**STATE OF HAWAII
DEPARTMENT OF TRANSPORTATION
HIGHWAYS**

**ADDENDUM NO. 1
FOR
KAUMUALII HIGHWAY DRAINAGE IMPROVEMENTS
VICINITY OF OMAO STREAM BRIDGE
DISTRICT OF KOLOA
ISLAND OF KAUAI
FEDERAL-AID PROJECT NO. ER-27(008)**

October 22, 2026

SECTION D
Scale: 1" = 5'
D2.1/D2.2

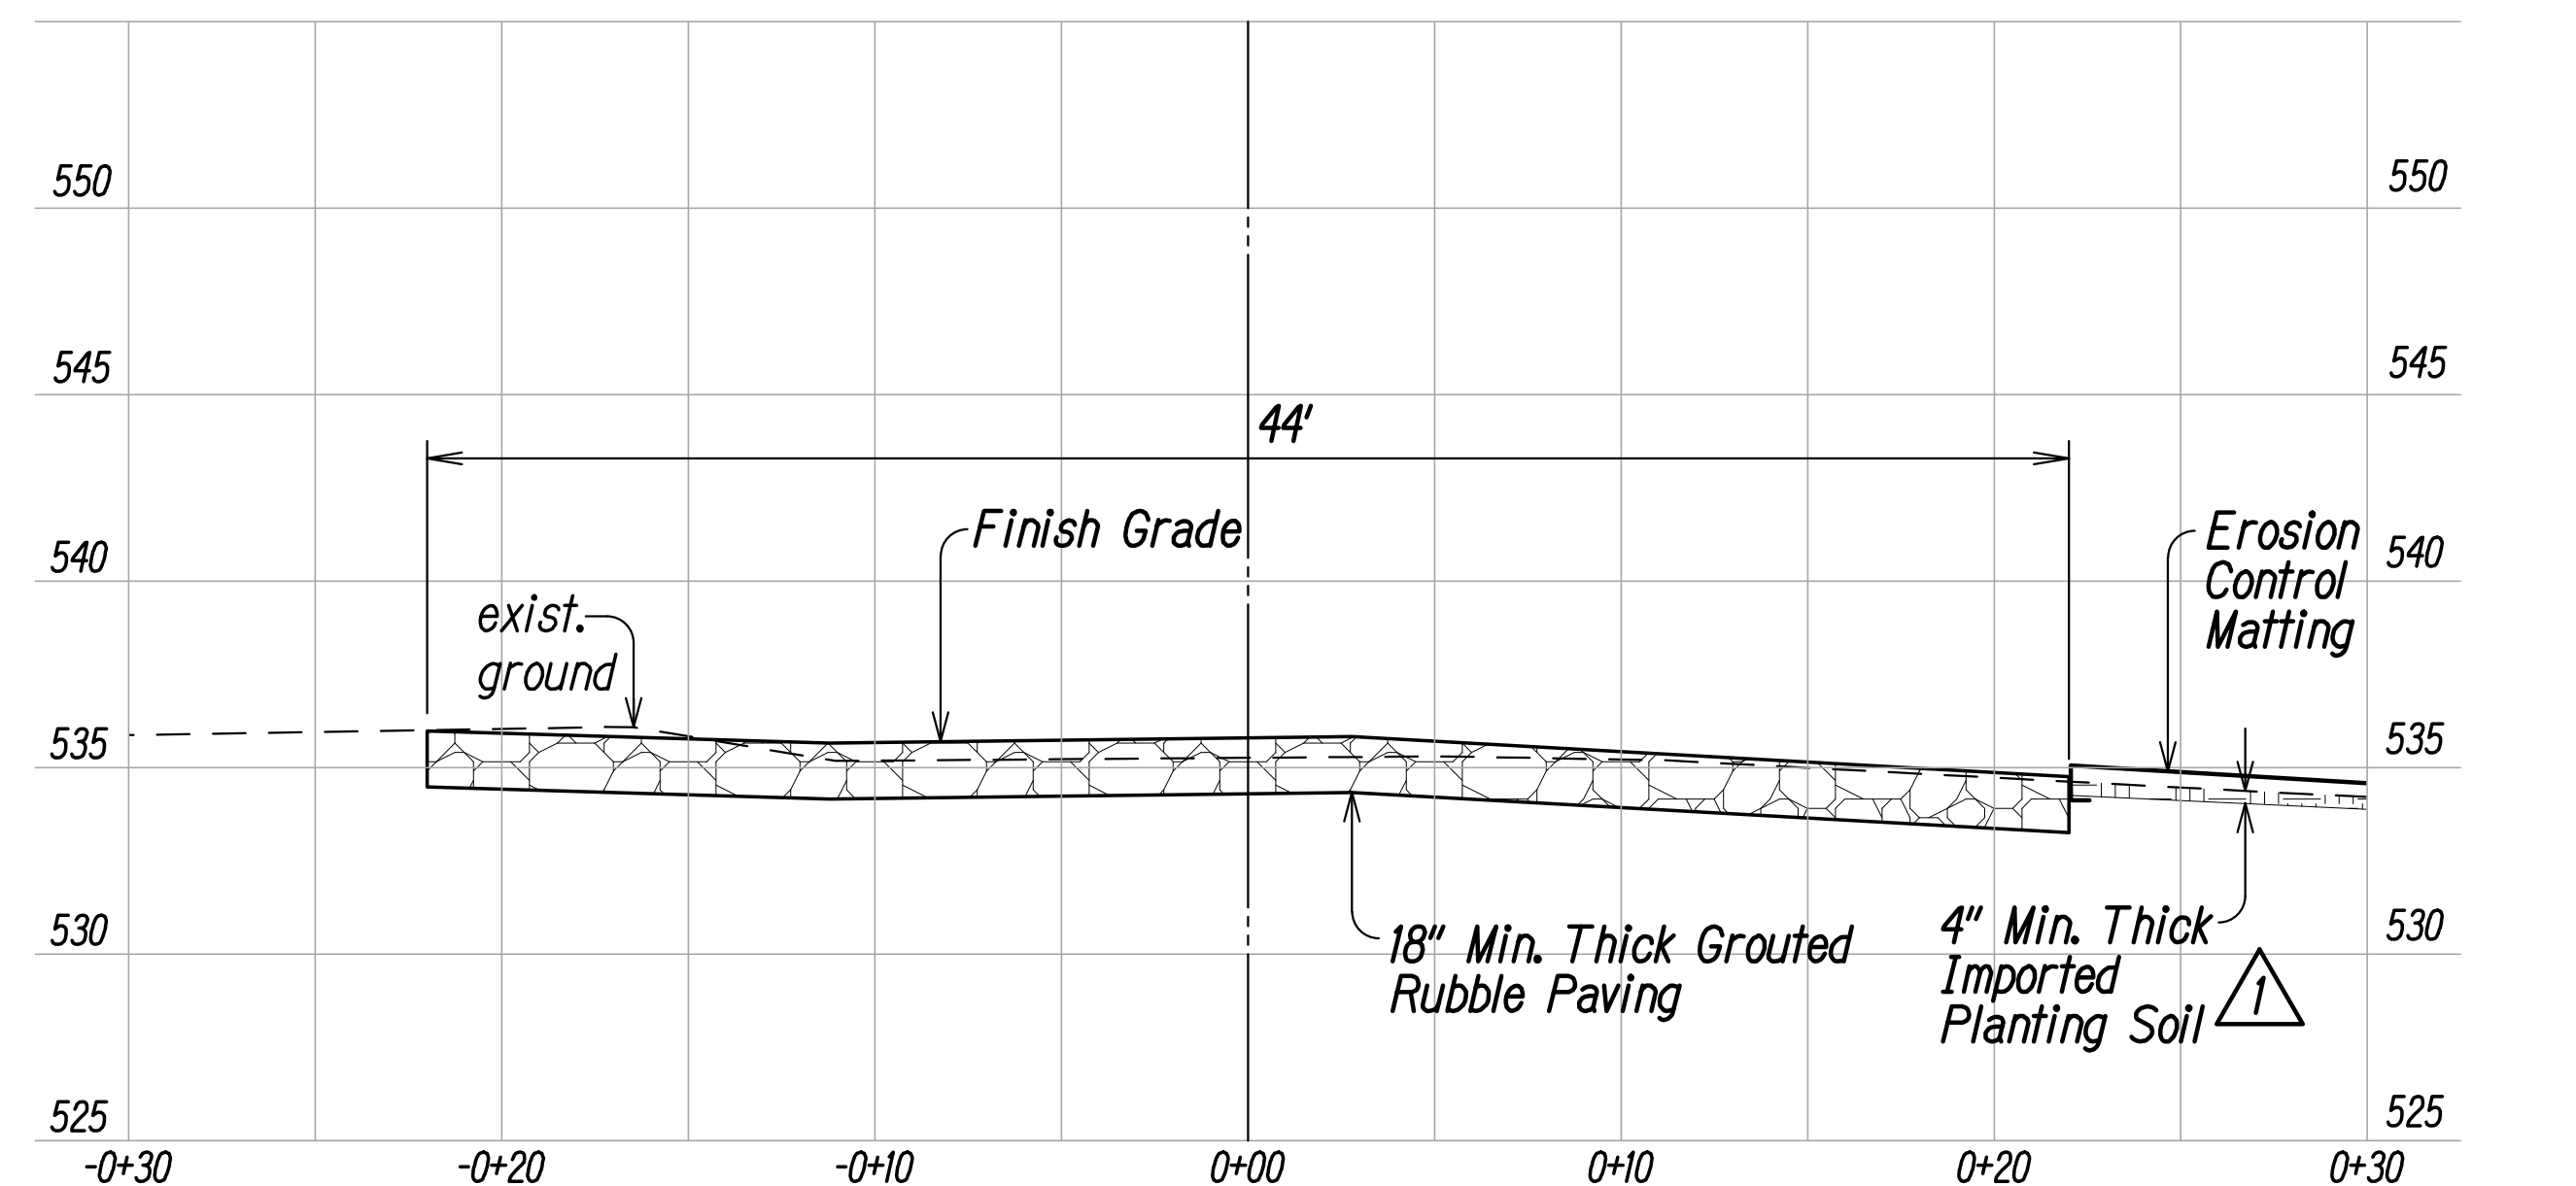
10/22/26 Revised sections to show 4" thick imported planting soil and grass.
